# A survey of methane point source emissions from coal mines in Shanxi province of China using AHSI on board Gaofen-5B

RC1: '[Comment on egusphere-2023-3047](#)', Anonymous Referee #1, 24 Jan 2024

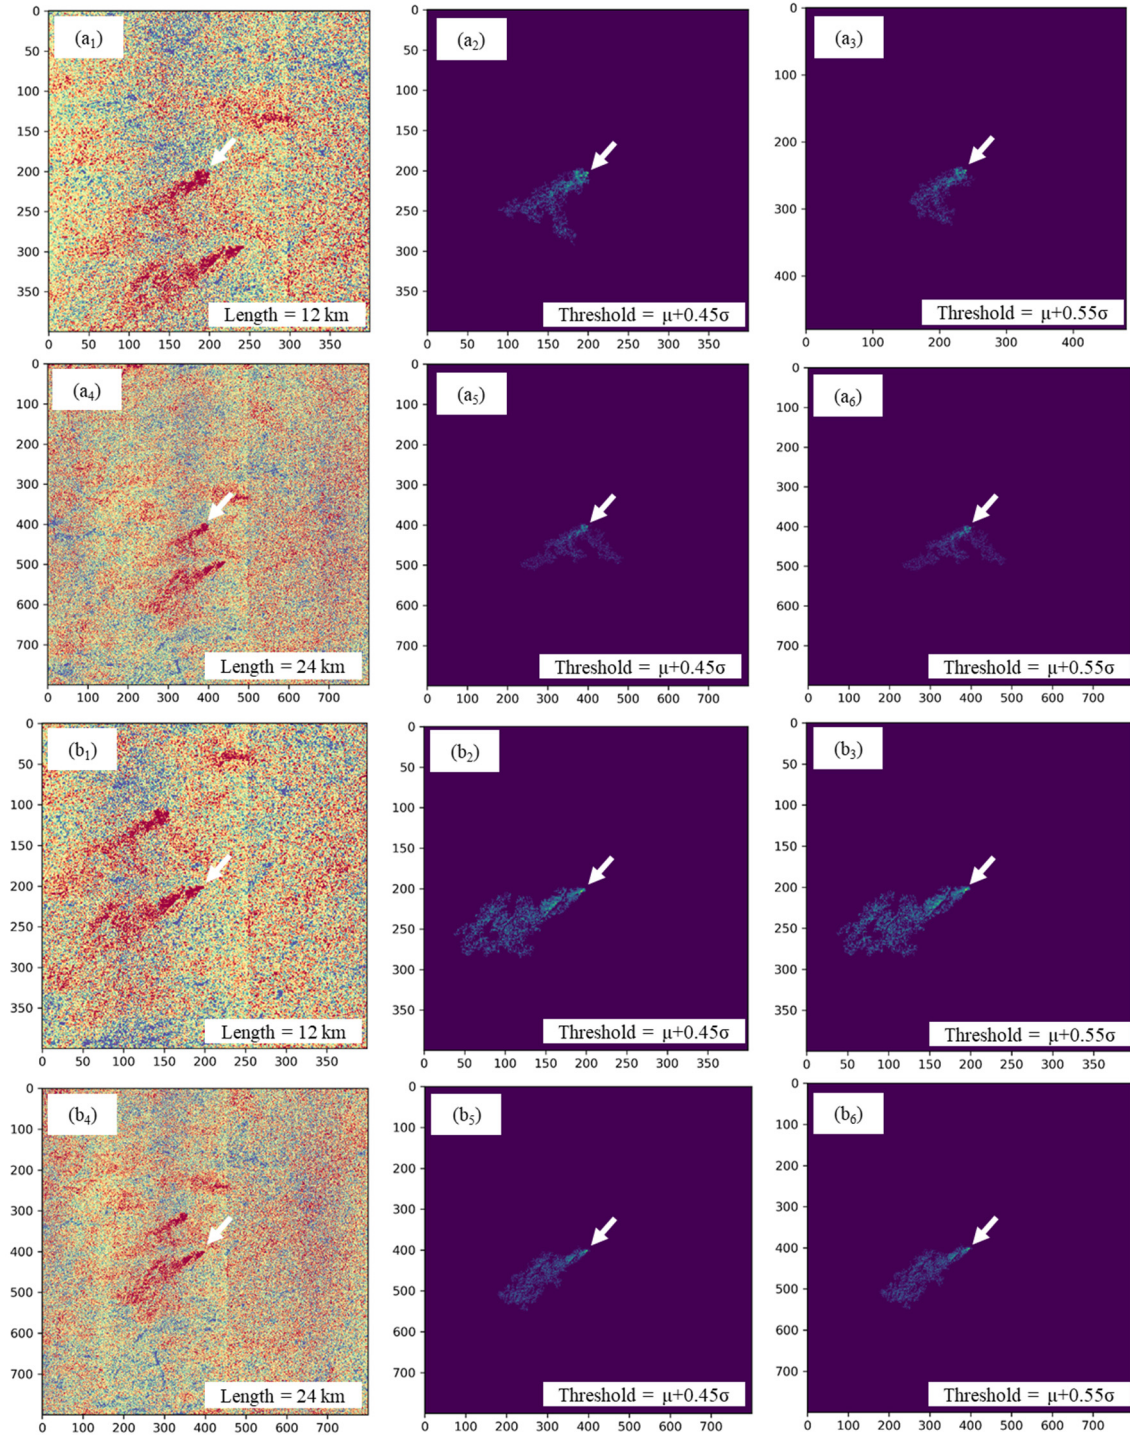
Section 3.3.3: To clarify the IME/measurement uncertainty part of this section, please describe your implementation of the flood-fill algorithm in more detail. It wasn't clear to me, for example, that it depended on defining a background. (And what is that background? See comments below.) Can you please lay this out in a few sentences?

Reply: We added detailed information in Section 3.3.1 (**Lines 197-204**): To carry out the flood-fill method in plume extraction, a background region needs to be defined to calculate the mean and standard deviation of  $\Delta XCH_4$  which set the basis for identifying anomalous high  $\Delta XCH_4$  in the plume relative to the background. In this study, for a specific plume, the origin is first pinpointed through visual interpretation. Then a background region is defined as a square using the source origin as the center for calculating the mean ( $\mu$ ) and standard deviation ( $\sigma$ ) of  $\Delta XCH_4$ . Finally, a threshold defined based on  $\mu$  and  $\sigma$  is used for the flood-fill algorithm to effectively segment the point source plume. The exact numbers for the background square length,  $\mu$  and  $\sigma$  are introduced in Section 3.3.3.

And we revised the description in Section 3.3.3 (Lines 232-236): In practice, for estimating IME and its uncertainty for a certain plume, we used 6 different background square lengths (from 12 km to 24 km with an interval of 2.4 km) and 6 different segmentation thresholds (from  $\mu+0.45\sigma$  to  $\mu+0.55\sigma$  with an interval of  $0.02\sigma$ ) for the flood-fill segmentation method (Figure C1). Different values of  $\mu$  and  $\sigma$  are calculated for different background regions.

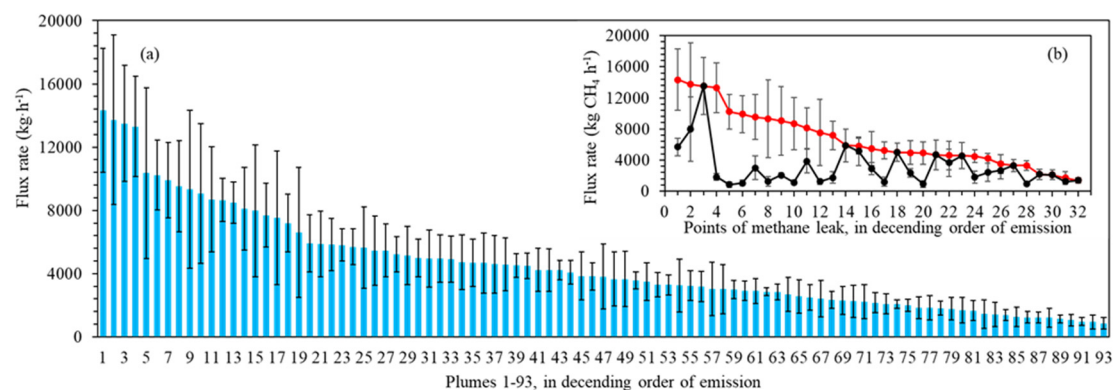
L. 226: A flat 50% wind error would underestimate uncertainty for slow winds and overestimate uncertainty for fast winds. Why not use a fixed absolute wind uncertainty? You have local measurements to compute such an error and that would seem more defensible than an arbitrary 50%.

Reply: Thanks for your great suggestion. In the revised paper, we added a paragraph to describe the new results with the wind error estimated from comparing ground-based measurements and ERA5. The comparison result shows an averaged difference of  $1.297 \text{ m}\cdot\text{s}^{-1}$ , which is then used as an absolute wind uncertainty for estimating the uncertainty in emission calculation. The updated results are shown in **Section 4.3.3** and **Figure D1**.

**Lines 405-411:** A flat 50% wind error could underestimate uncertainty for slow winds and overestimate uncertainty for fast winds. Therefore, we carried out an evaluation of the plume emission uncertainty using the absolute wind error ( $1.297 \text{ m}\cdot\text{s}^{-1}$  on average) estimated by comparing wind speeds from ERA5 and local meteorological stations in Shanxi. The results of  $\text{CH}_4$  flux rates and their uncertainty are shown in **Figure E1**. As we expected, the uncertainty of flux decreased/increased at high/low wind speed, respectively. In addition, the impact of wind speed uncertainties accounts for approximately 86.31%, which is similar to the previous result based on a flat 50% wind error. This result supports the fact that wind speed remains the dominant factor contributing to the uncertainty in estimating  $\text{CH}_4$  point source emissions.

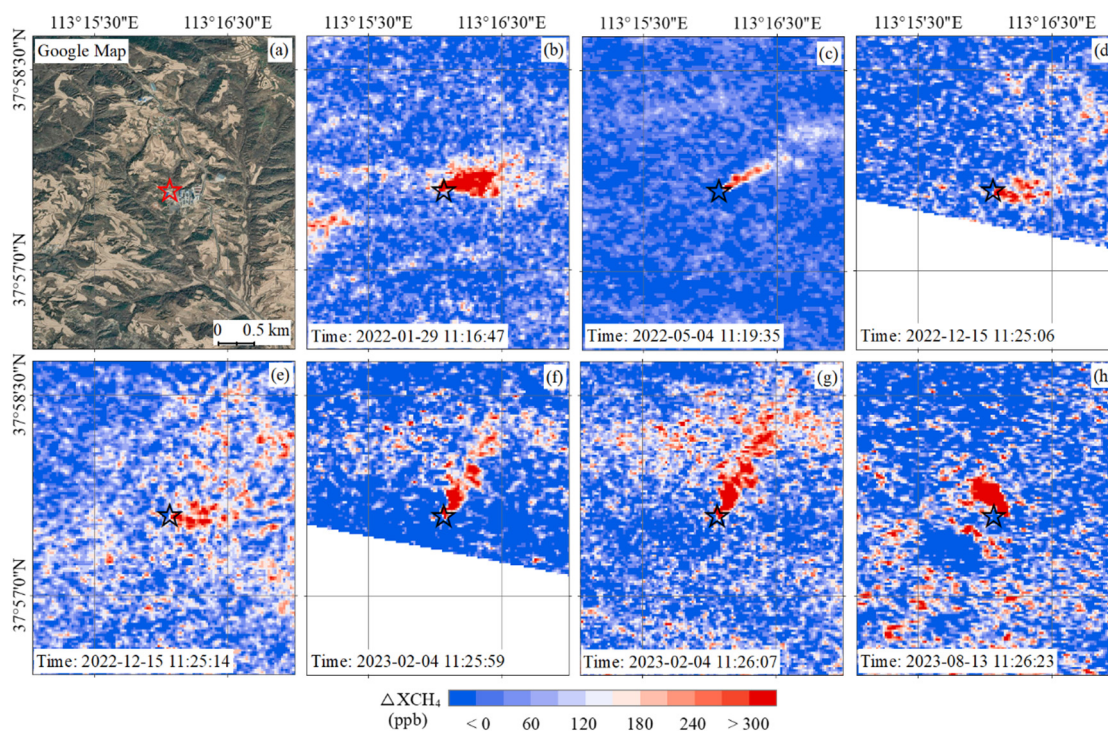
Figure 3: It would be helpful to note the lat/lon of the source somewhere in the caption and main text. What do the black ellipses signify? I assume the inset times are local?

Reply: The location information of the origin (Lat 37°57'36", Lon 113°16'04") has been added. In order to avoid any ambiguity, we removed the black ellipses and marked the original of the point sources with a red/black star. The observation time is indeed presented in standard Beijing Time (UTC+8; Lon=120°), which is close to the local time (Lon=113°). We have revised the related descriptions in the caption for **Figure 3 (Lines 261-264)**.

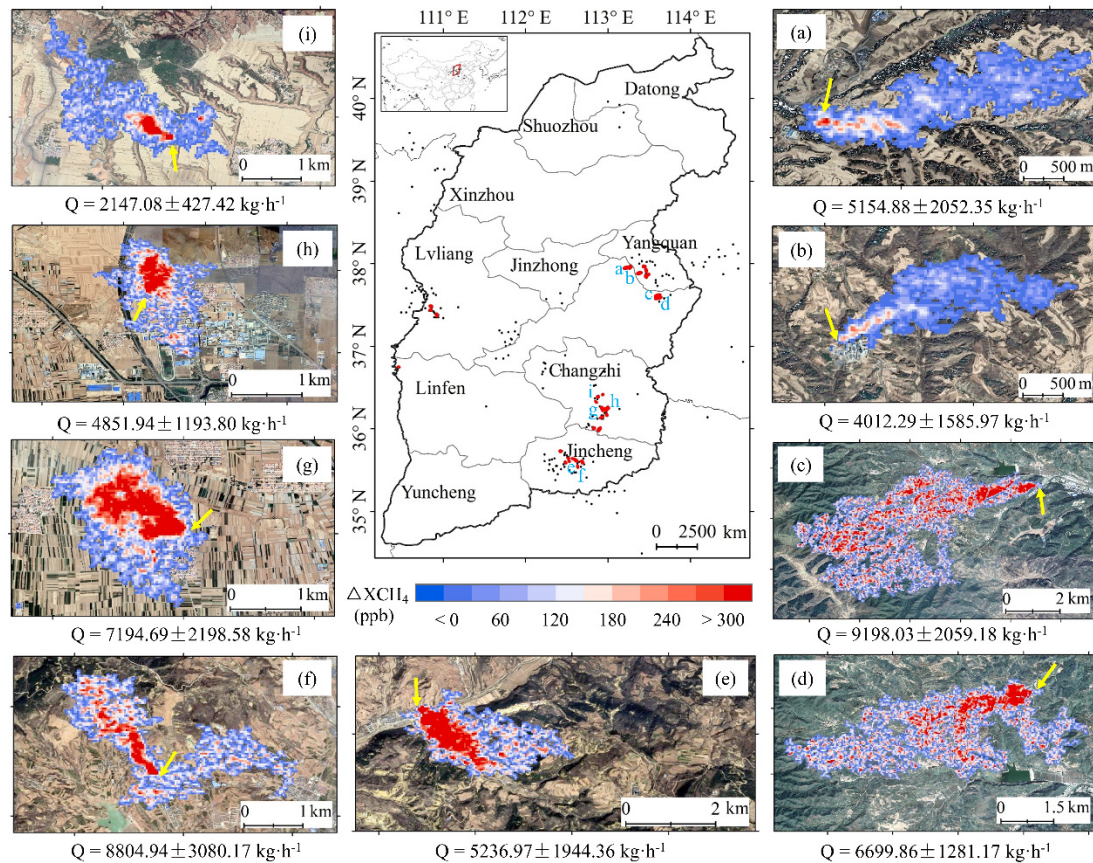
Figure 6: Please mark the source locations on the plot – in some cases I can't tell where the plume starts/ends.

Reply: We have added yellow arrows in Figure 6 to indicate the start of each point source (**Line 337 and Line 340**).

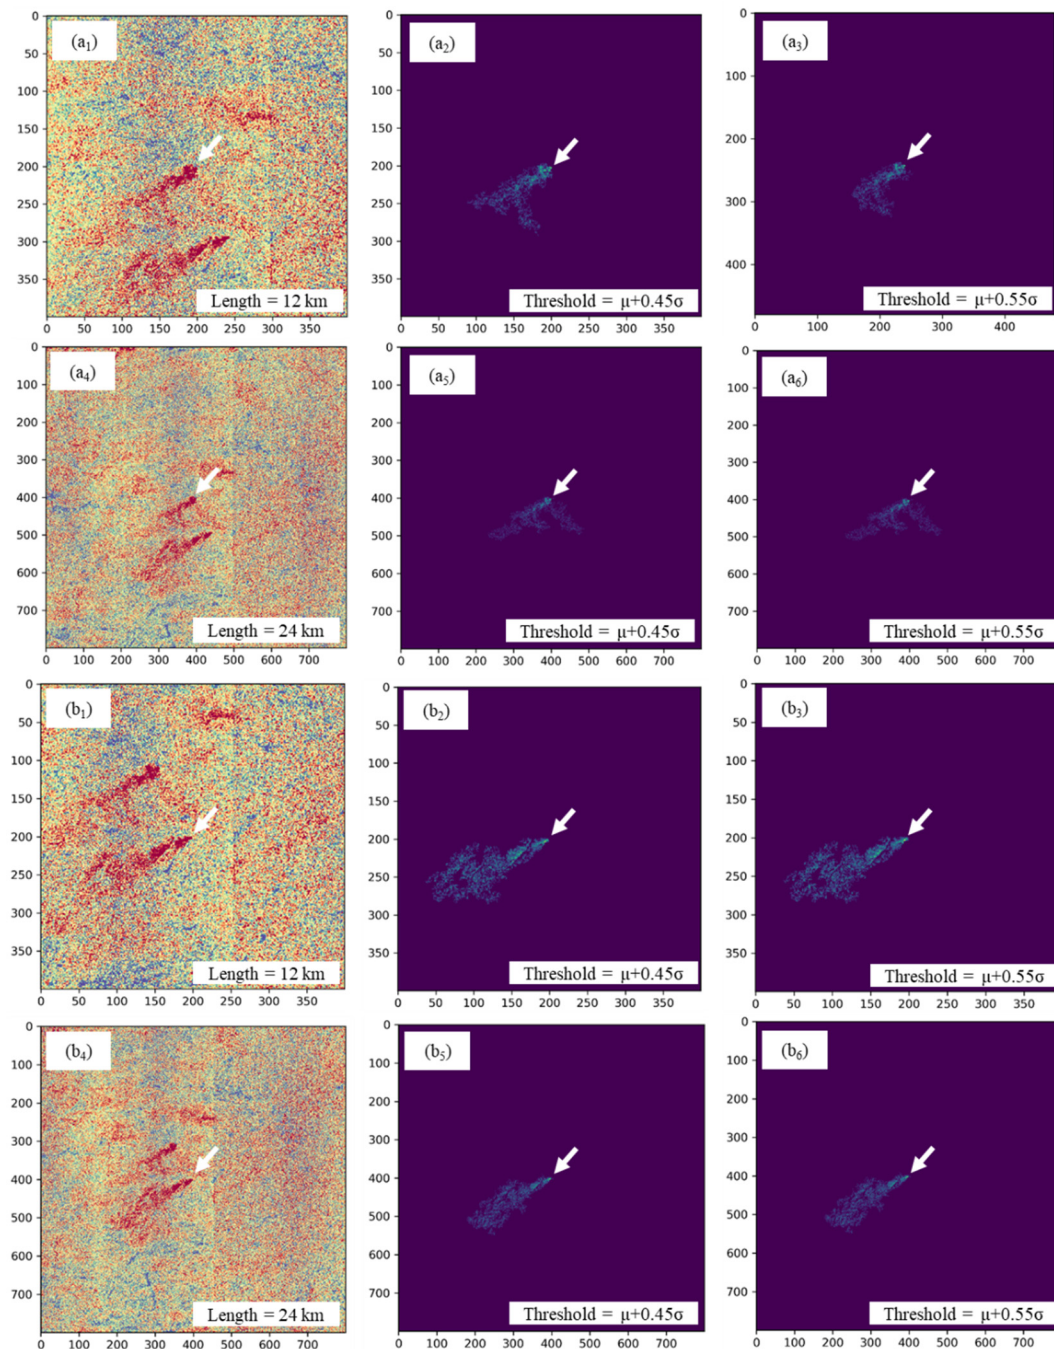
1. It is apparent that the estimates are sensitive to the selection of background, which is acknowledged in the manuscript, and is also demonstrated with a good example using the same background region in Fig.5a&b. The question is how the background regions were selected in practice? i.e., where is "a background region in square (with length of 600 pixels, which is 18 km)" located?

Reply: We added the detailed information in Section 3.1.1 (**Lines 197-203**): To carry out the flood-fill method in plume extraction, a background region needs to be defined to calculate the mean and standard deviation of  $\Delta XCH_4$  which set the basis for identifying anomalous high  $\Delta XCH_4$  in the plume relative to the background. In this study, for a specific plume, the origin

is first pinpointed through visual interpretation. Then a background region is defined as a square using the source origin as the center for calculating the mean ( $\mu$ ) and standard deviation ( $\sigma$ ) of  $\Delta XCH_4$ . Finally, a threshold defined based on  $\mu$  and  $\sigma$  is used for the flood-fill algorithm to effectively segment the point source plume. The exact numbers for the background square length,  $\mu$  and  $\sigma$  are introduced in Section 3.3.3.

We have also revised the related descriptions in **Lines 231-236**: In practice, for estimating IME and its uncertainty for a certain plume, we used 6 different background square lengths (from 12 km to 24 km with an interval of 2.4 km) and 6 different segmentation thresholds (from  $\mu+0.45\sigma$  to  $\mu+0.55\sigma$  with an interval of  $0.02\sigma$ ) for the flood-fill segmentation method (**Figure C1**). Different values of  $\mu$  and  $\sigma$  are calculated for different background regions.

We have also added **Figure C1** in the Appendix to demonstrate examples of background selection.

Figure. Scatter plot between the estimates of methane emissions and wind speed in this study.

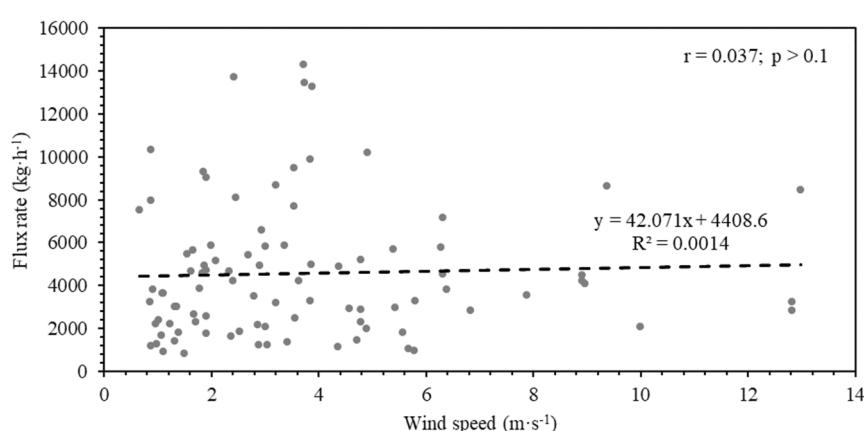
2. Are the estimates of methane emissions correlated with wind speed? As the wind speed is low, the dispersion of the methane plumes may be very uncertain, and the estimates may be biased.

Reply: Based on the wind speeds from ERA5 and the corresponding CH<sub>4</sub> emission estimations, we made a scatter plot as shown in the following **Figure**. No clear correlation can be seen from the data, suggesting the emission estimations are not biased due to wind speeds. We have added the following figure and related statements in the revised manuscript.

**Figure. Comparison of point source emission statistics between TROPOMI (a) and GF-5B AHSI (b) in Shanxi, China. TROPOMI detected a total of 134 points (Schuit et al., 2023), while GF-5B AHSI identified 93 plumes in this study.**

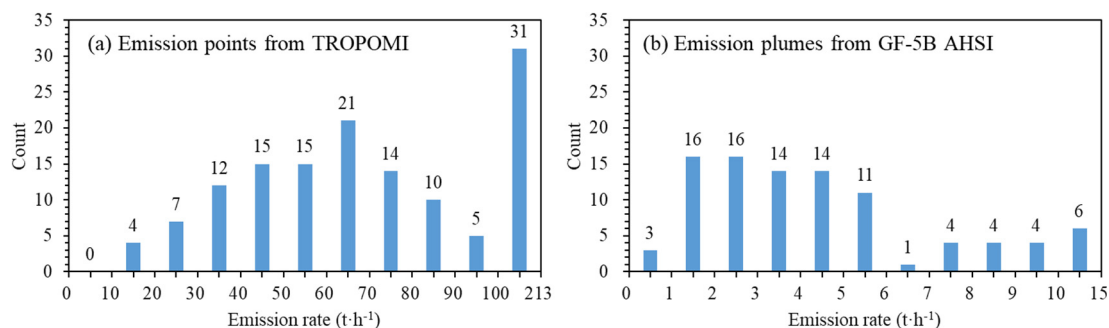
3. I understand that the overall emission flux rate of 13.26 ton h<sup>-1</sup> in Shanxi refers to the 32 coal mines between 2021 and 2023. How does it relate to the total coal mine emissions? How does it compare with the estimates from TROPOMI? What's the detection limit of GF-5B/AHSI?

We have made a comparison of emissions estimated from TROPOMI (**Schuit et al., 2023**) and this study as shown in the following **Figure**. Notably, the emission rate of plumes from GF-5B

AHSI are very different from results by TROPOMI. For the detection limit, the emission rates of all detected plume are shown in this study (Figure 7), we can see that the smallest plume has an emission rate of  $761.78 \pm 185.00 \text{ kg}\cdot\text{h}^{-1}$  which may represent the detection limit of GF-5B AHSI.

**Figure B1.** Histogram of the elevation for the detected plumes in Shanxi. The elevation data is from the DEM shown in Section 2.3.

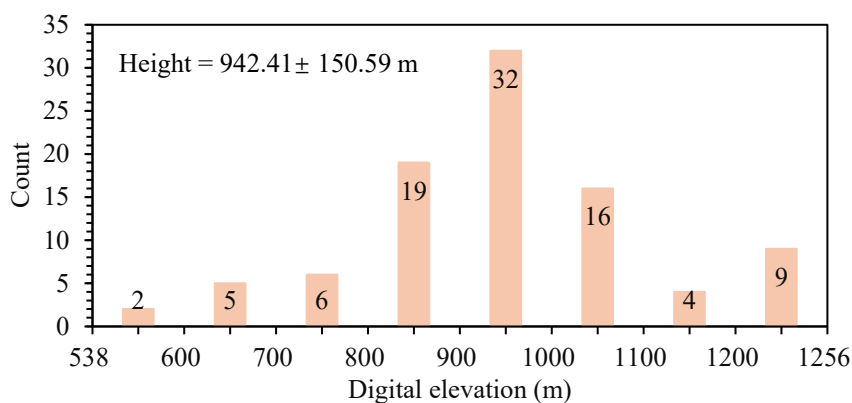
L204-205: k may be affected by a few factors, such as surface pressure, temperature, and water vapor. How would these affect the estimate?

Reply: Thank you for your great suggestion, we have updated the  $k$  value using the surfaced pressure that is representative for the detected plumes in Shanxi. In addition, all results in the revised paper have been updated based on this updated  $k$  value.

We revised the related descriptions in **Lines 213-218**:  $k$  is the scaling factor converting  $\Delta XCH_4$  from volume mixing ratio to mass based on Avogadro's law, considering the pixel resolution of GF-5B/AHSI to be 30-meter. In **Guanter et al. (2021)**,  $k$  is defined as  $5.155 \times 10^{-3} \text{ kg} \cdot \text{ppb}^{-1}$  derived from surface pressure of one standard atmosphere. However, the average elevation of the identified plumes is 942.41 meters (**Figure B1**), whose surface pressure (900.64 hPa) is about 10% less than one standard atmosphere. Therefore, we calculated a new  $k$  based on the derived averaged surface pressure for all the identified plumes. The derived  $k$  value ( $4.565 \times 10^{-3} \text{ kg} \cdot \text{ppb}^{-1}$ ) is then used for estimating IME in this study.

**Figure D1.** The full images of  $\Delta XCH_4$  for Figure 3f (a) and Figure 3g (b). The plume target (pointed by the white arrow) appears at the overlapping region of the two images.

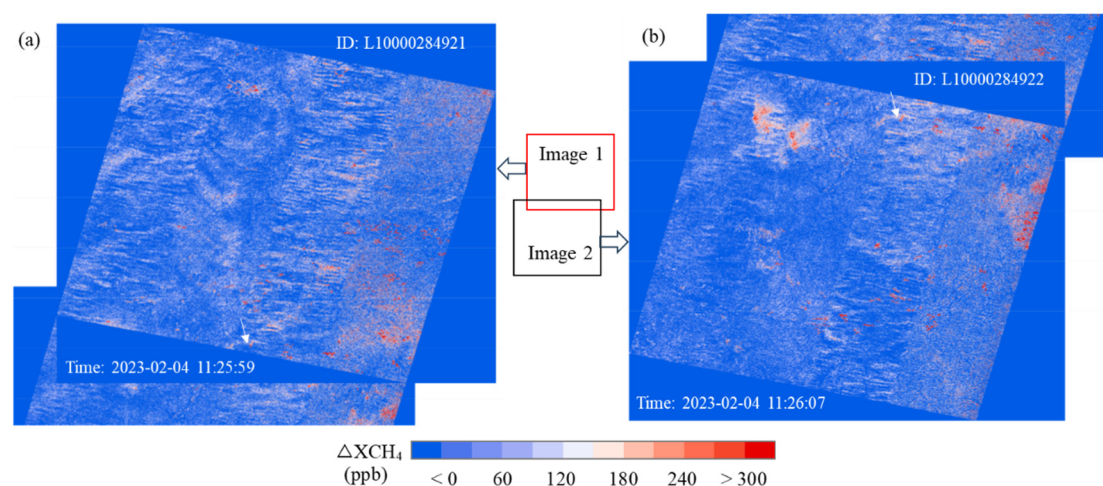
L241-243: "as the plumes appears at different locations of the imaging scene. The plumes appear at the bottom of the scene in Figure (f) and at the top in Figure (g)", why does the position of the plumes in the scenes matter?

Reply: The retrieval of  $\Delta XCH_4$  relies on the quality of the spectra, as quantified by its signal to noise ratio (SNR). When plumes appear at different locations of the imaging scene (as illustrated in the following **Figure D1**), they may be observed by different detectors with

different SNR of the instrument. Therefore, as we explained in the manuscript, the difference in  $\Delta XCH_4$  may be slightly caused by the different signal noise ratio of the detectors.

“as the plumes appear at different locations of the imaging scene. They may be observed by different detectors with different SNR of the instrument that affect the detection accuracy of the plumes.”
